Manual 03A, Rev. 19

Energy Management System (EMS) Model Updates and Quality Assurance (QA) 2020 Periodic Review

Maria Baptiste, Sr. Business Analyst
Model Management Department
Markets & Reliability Committee
November 19, 2020

Bulk Ratings Changes:

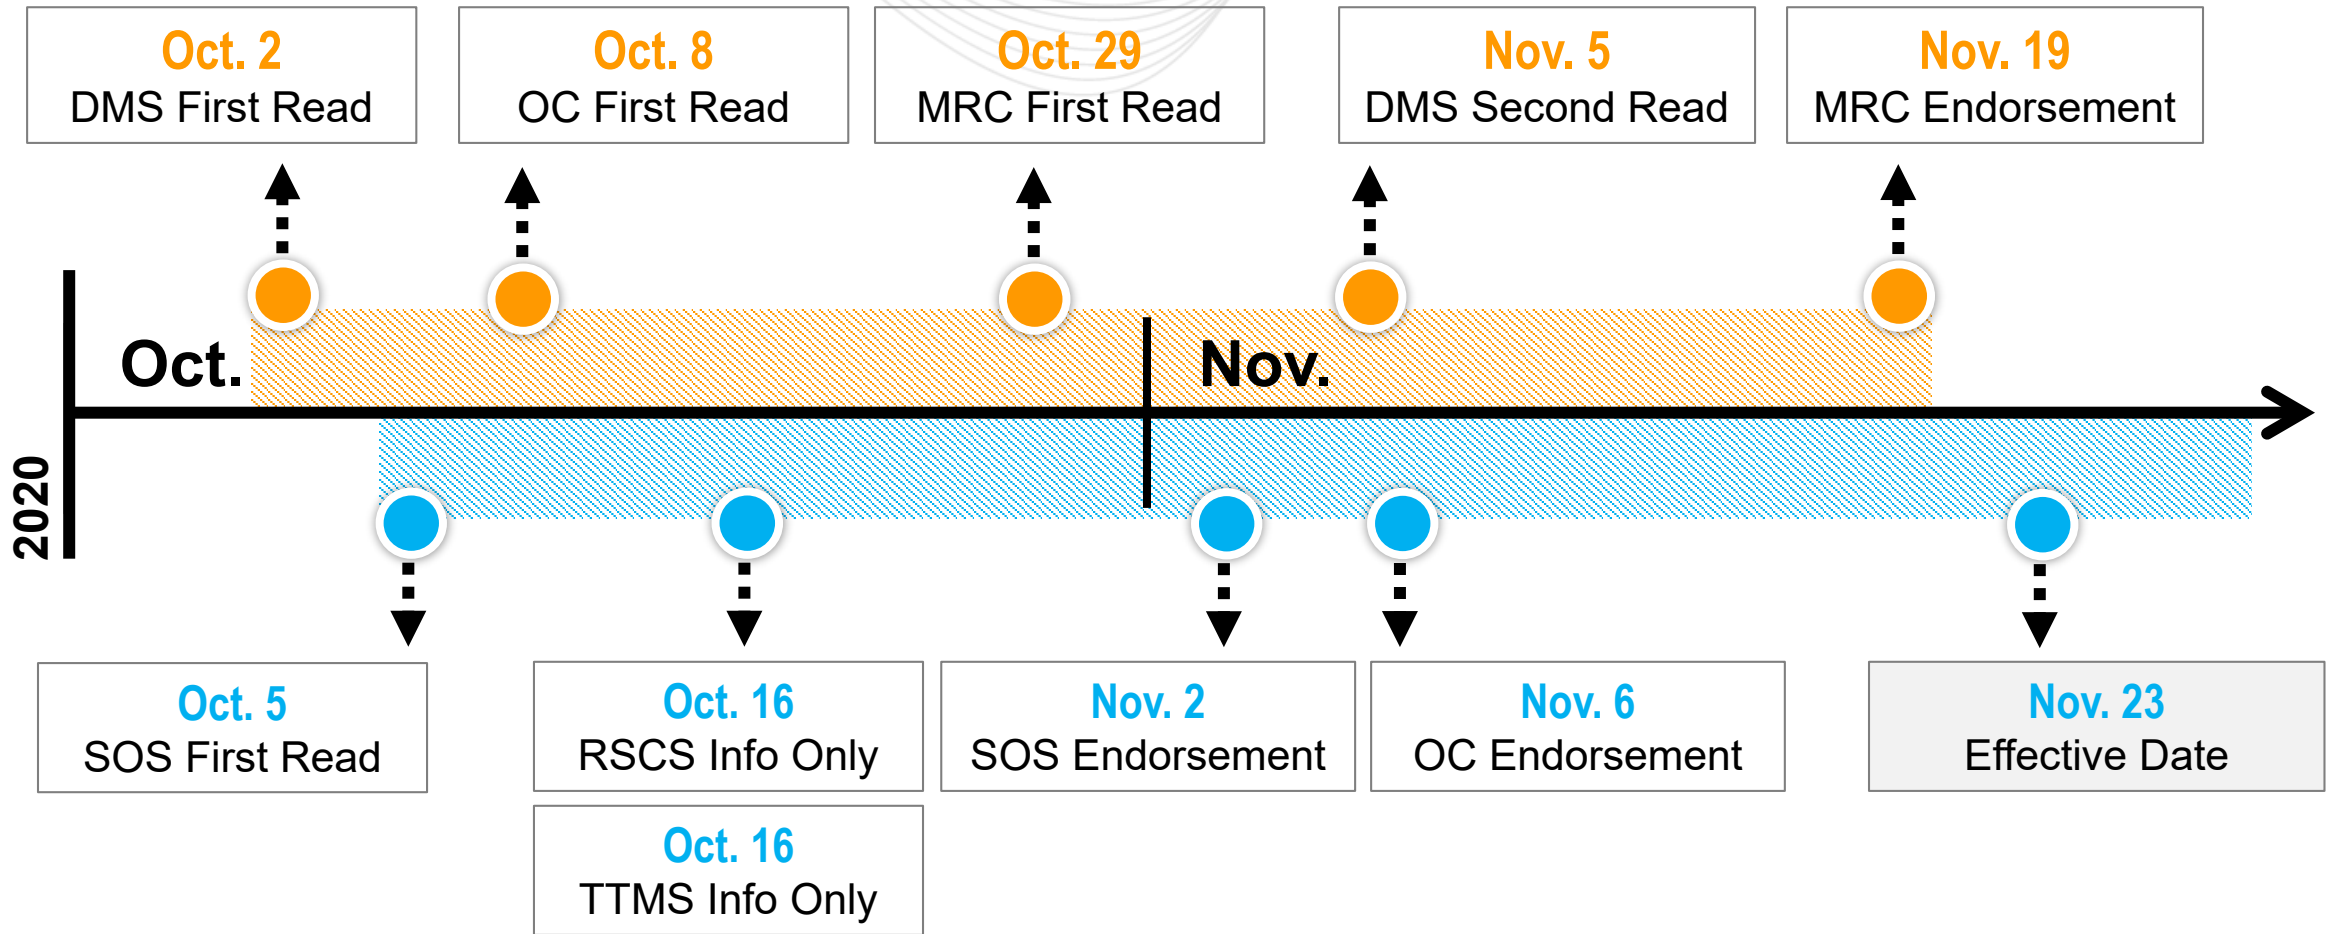
- Able to make changes outside of a scheduled model build
- Removed reference to Appendix C, Exhibit of MPs (unrelated to text)
